**BUSHEHR PETROCHEMICAL COMPANY
MEG PLANT**

HAZOP REPORT

**BUPC MEG Plant HAZOP & SIL Report –
N2 and Air Compressor
Detailed Design**

**HAZOP & SIL REPORT
BUPC MEG PLANT - AIRPACK**

DRAWING TITLE: 17811-03 P&ID FOR NITROGEN GAS BOOSTER

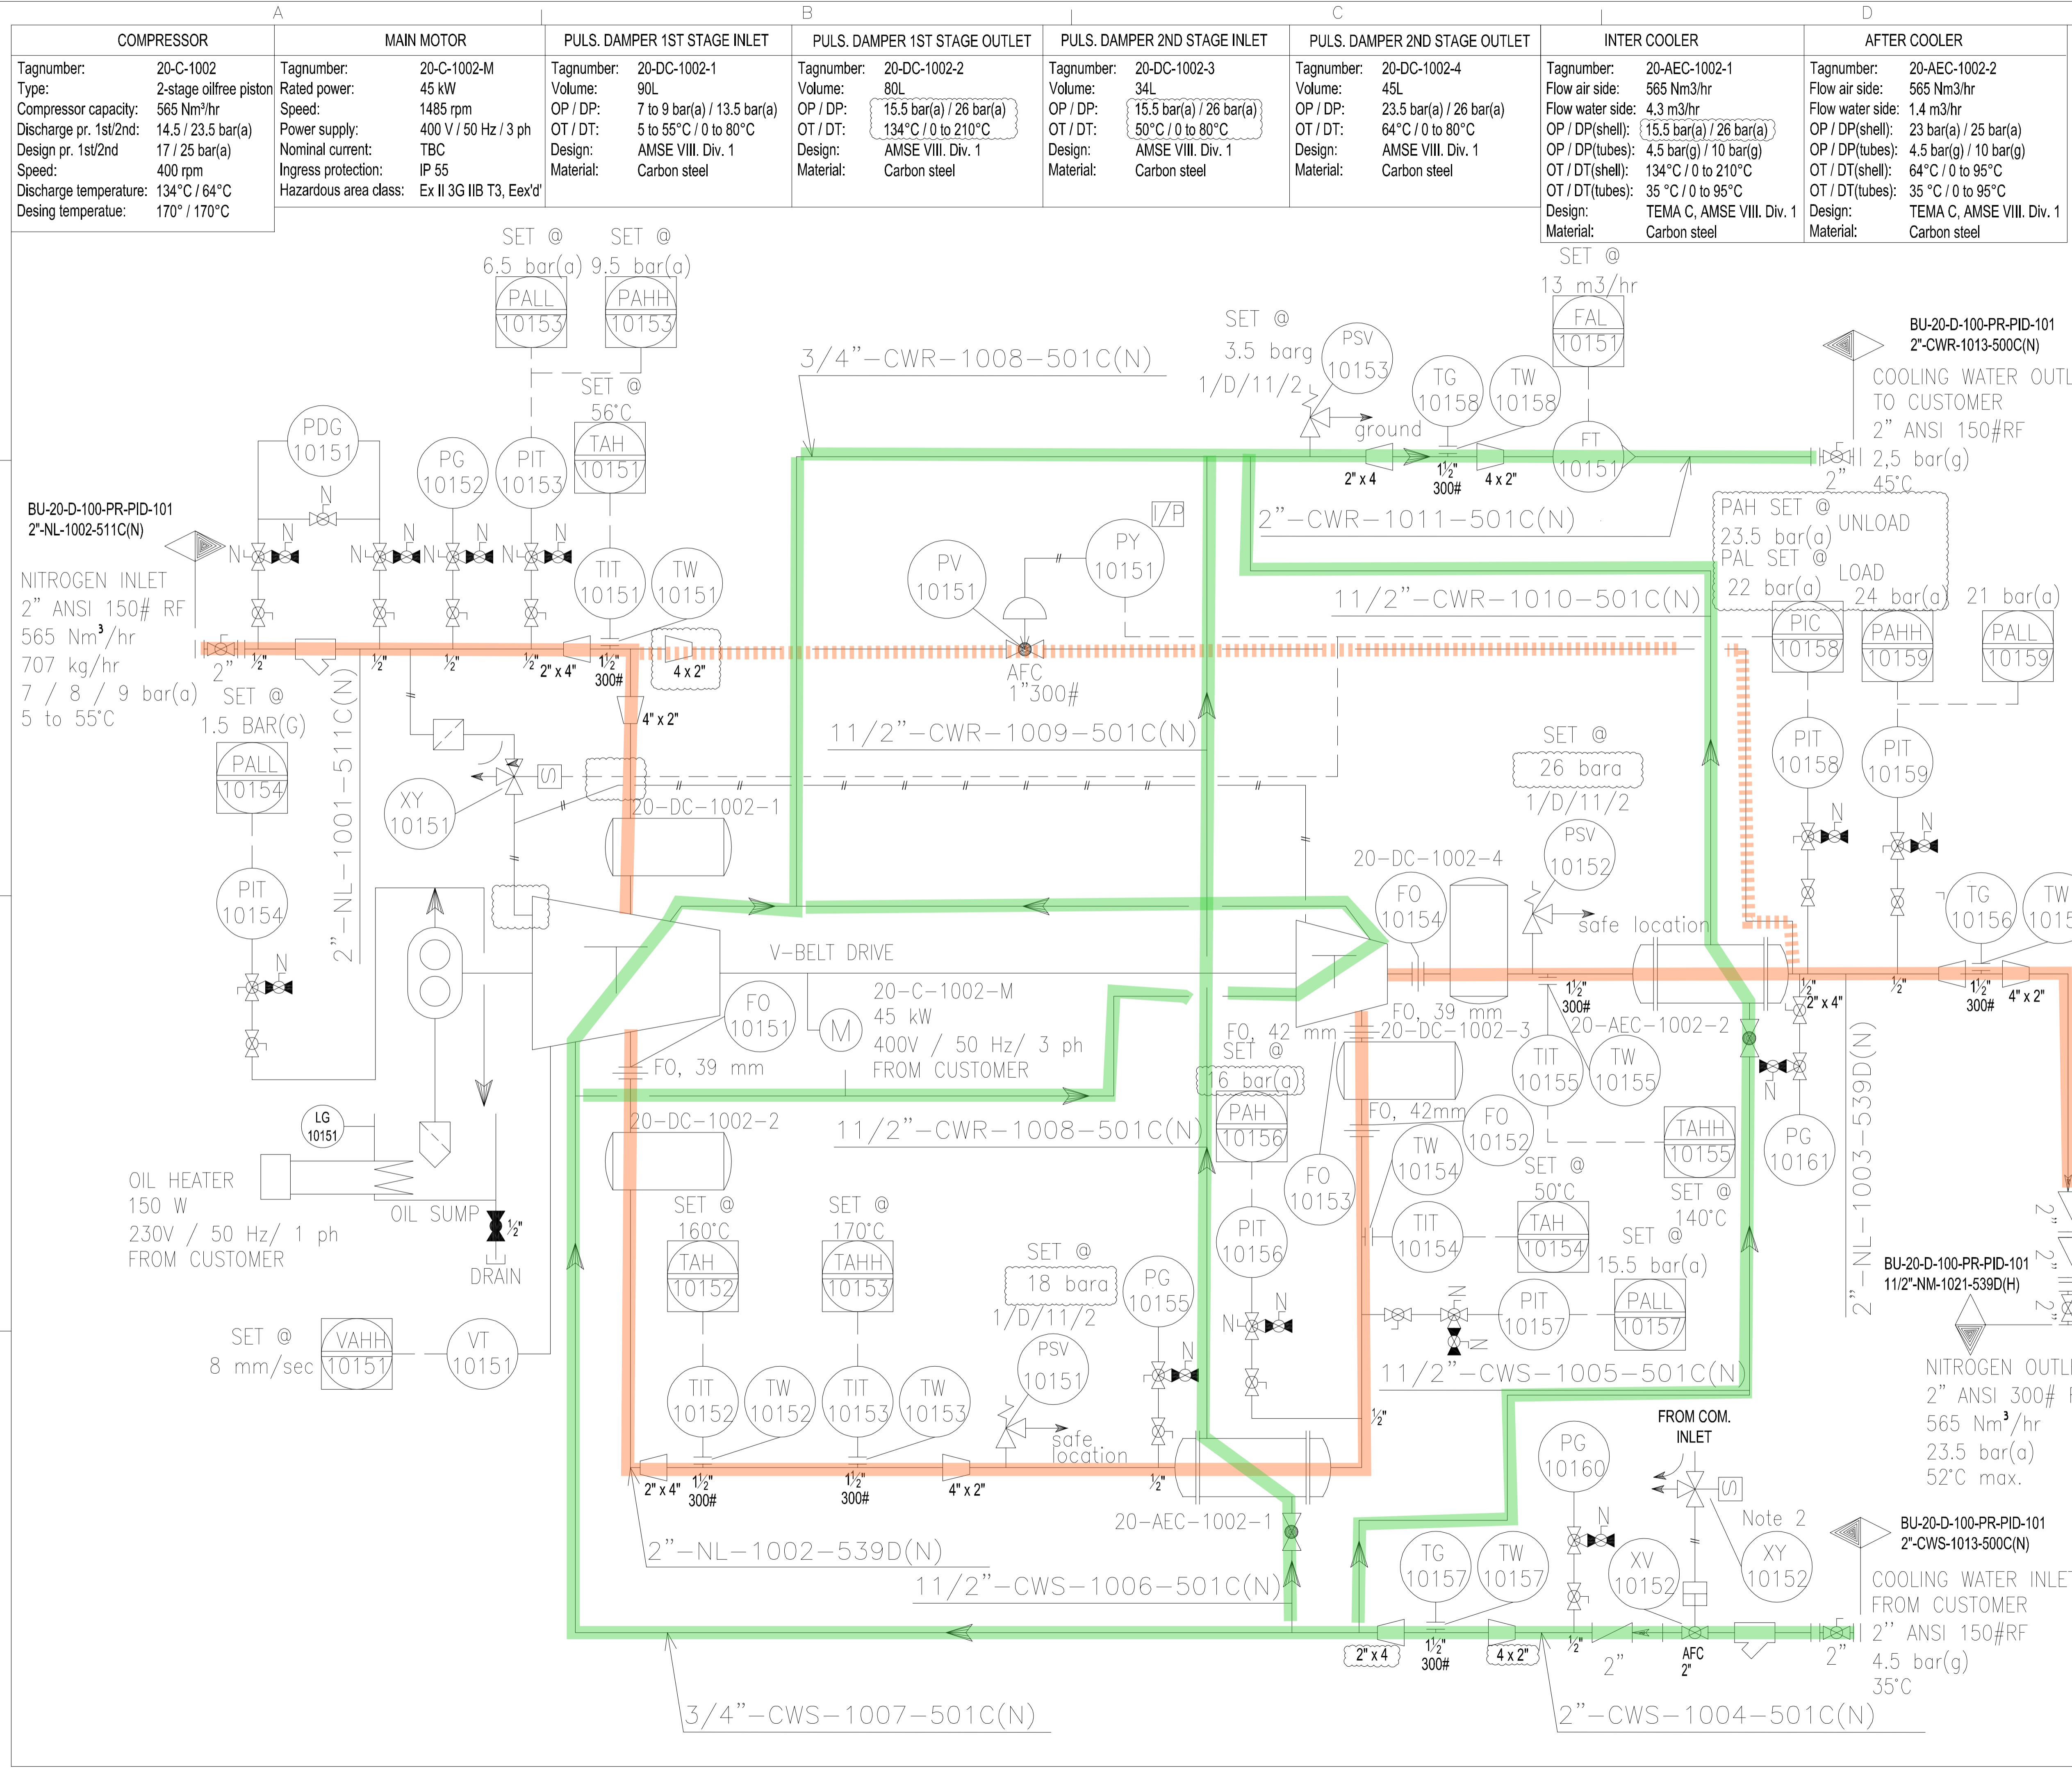
Node 1: Nitrogen

Node 2: Cooling Water N2 Compressor

DRAWING TITLE: 17811-03 P&ID FOR INSTRUMENT AIR COMPRESSOR

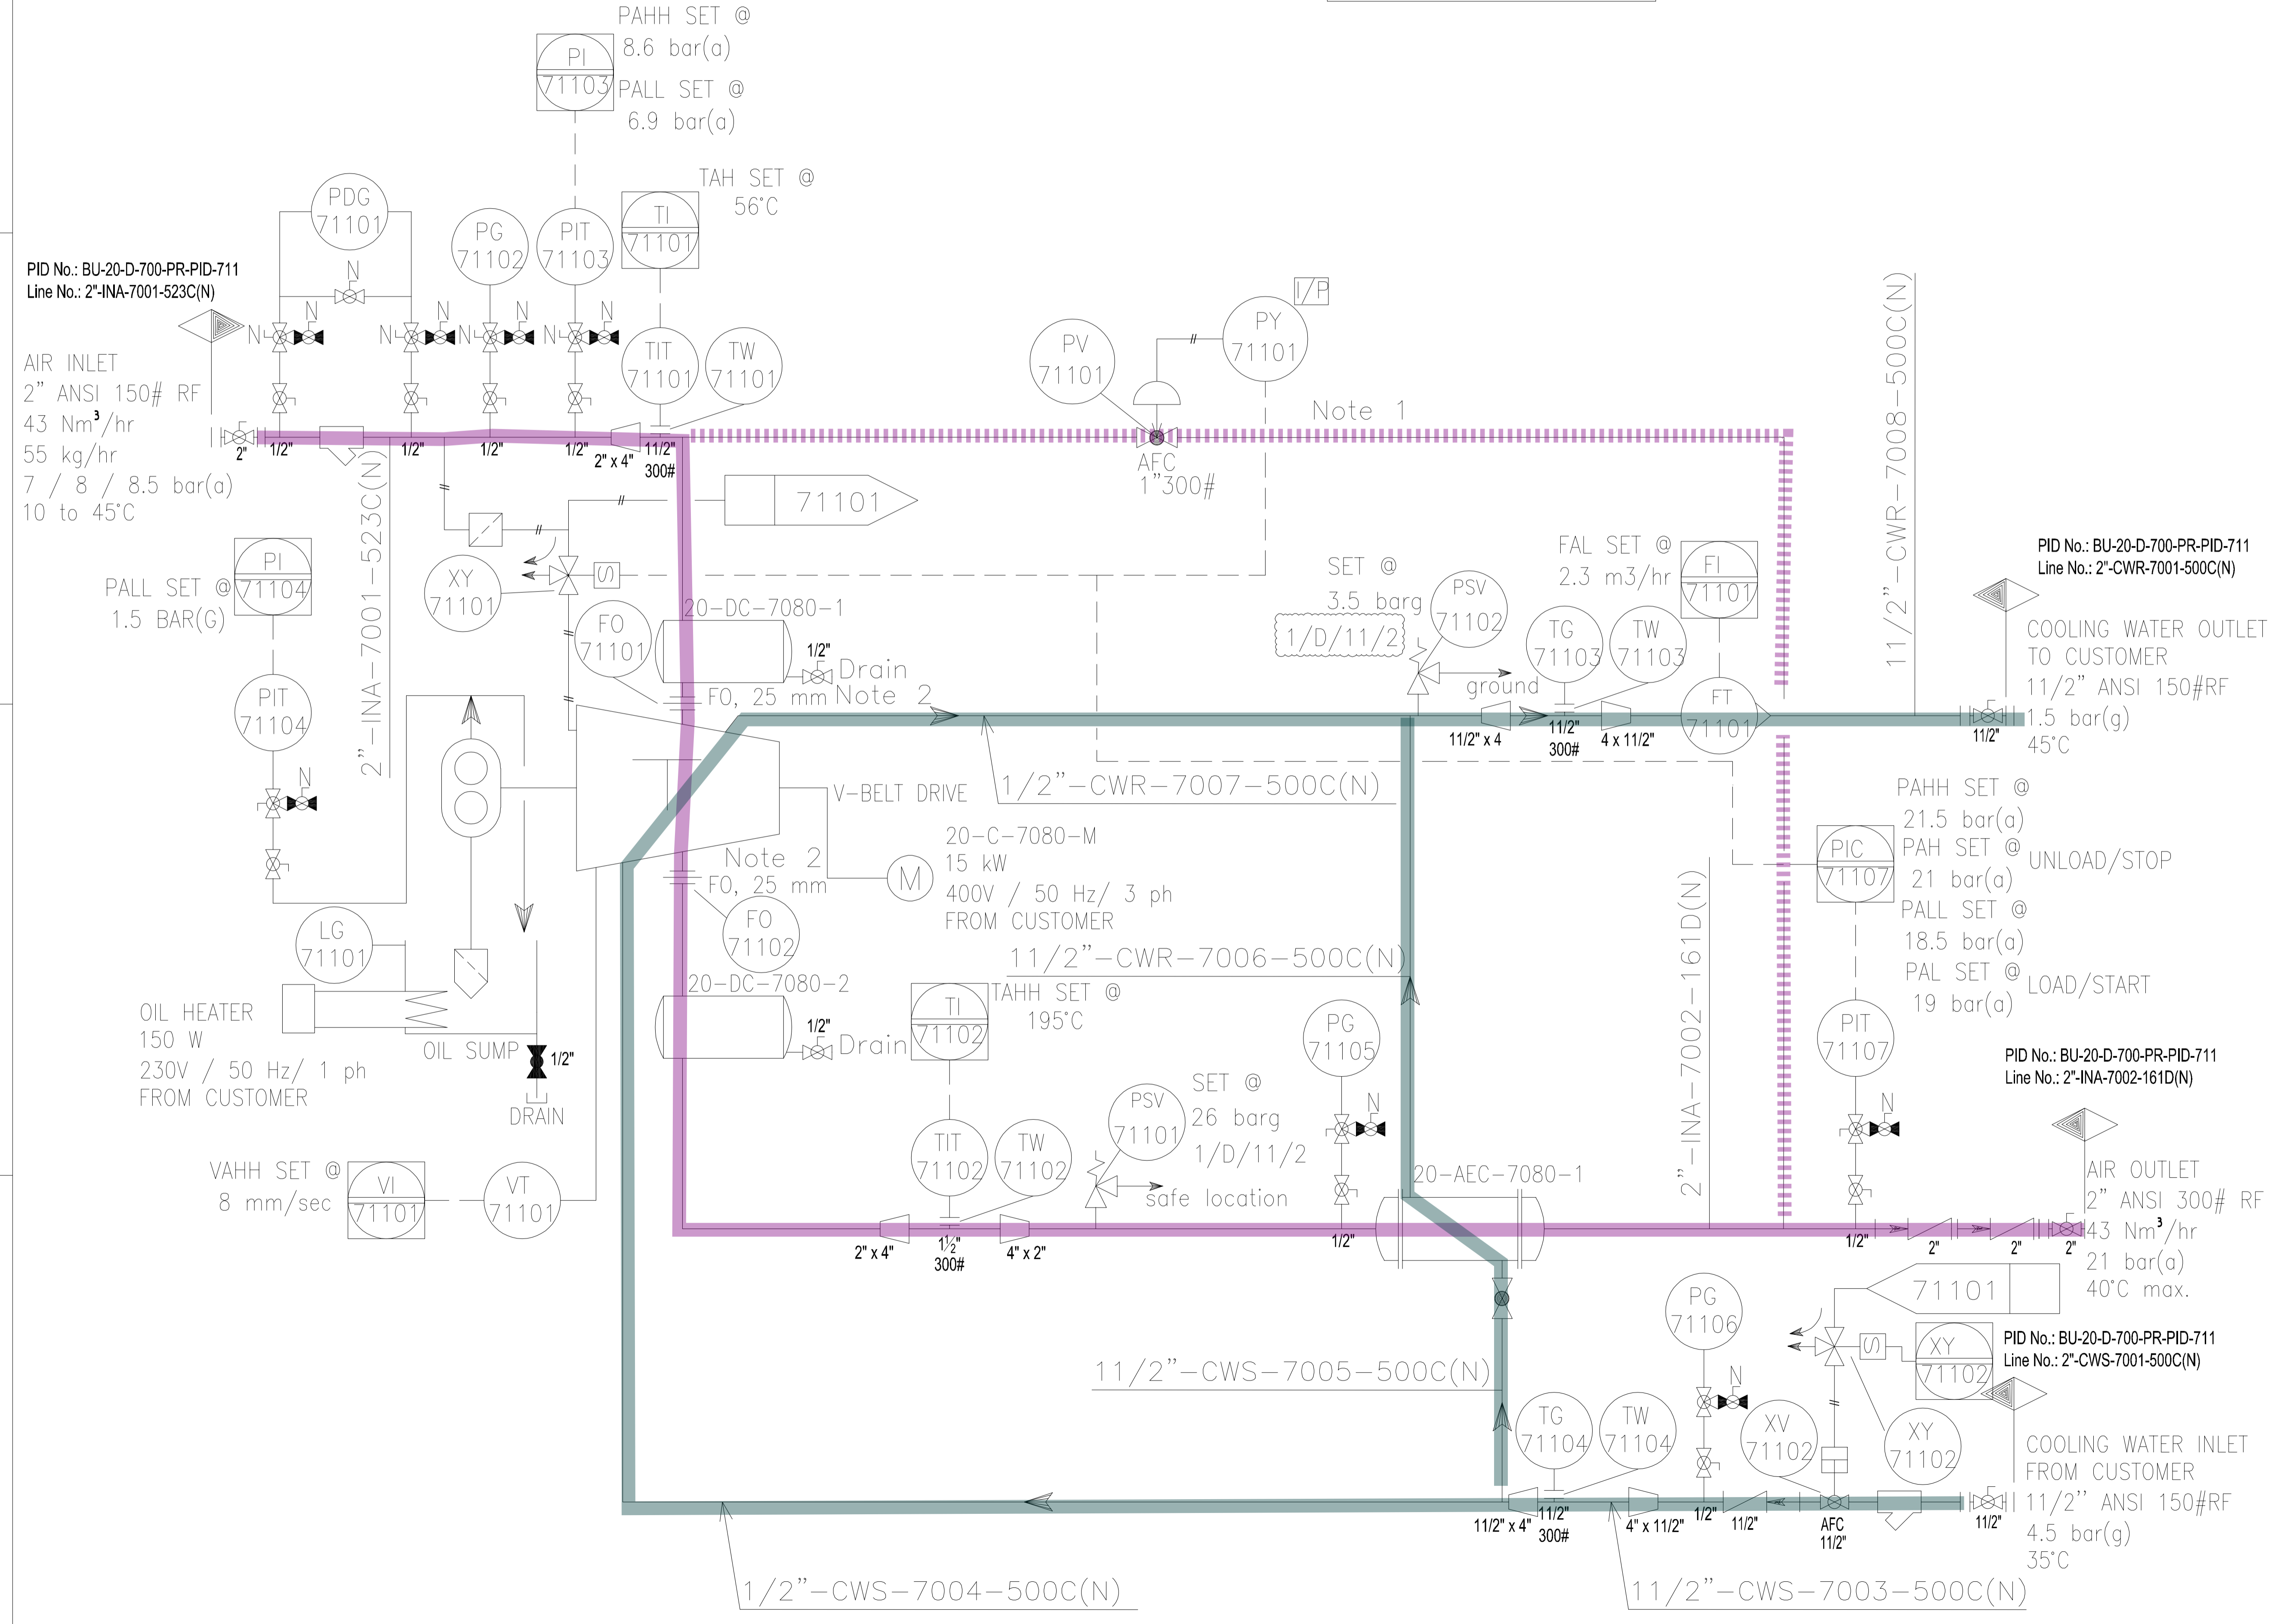
- This line is to recycle the flow that is not required to go into the system any additional flow is recycled to the inlet based on pressure setting on PIT-71107
- FO (orifice) have been added based on preliminary pulsation study
- Compressor starts by means of PIT-71107 low pressure and stops by means on PIT-71107 high pressure
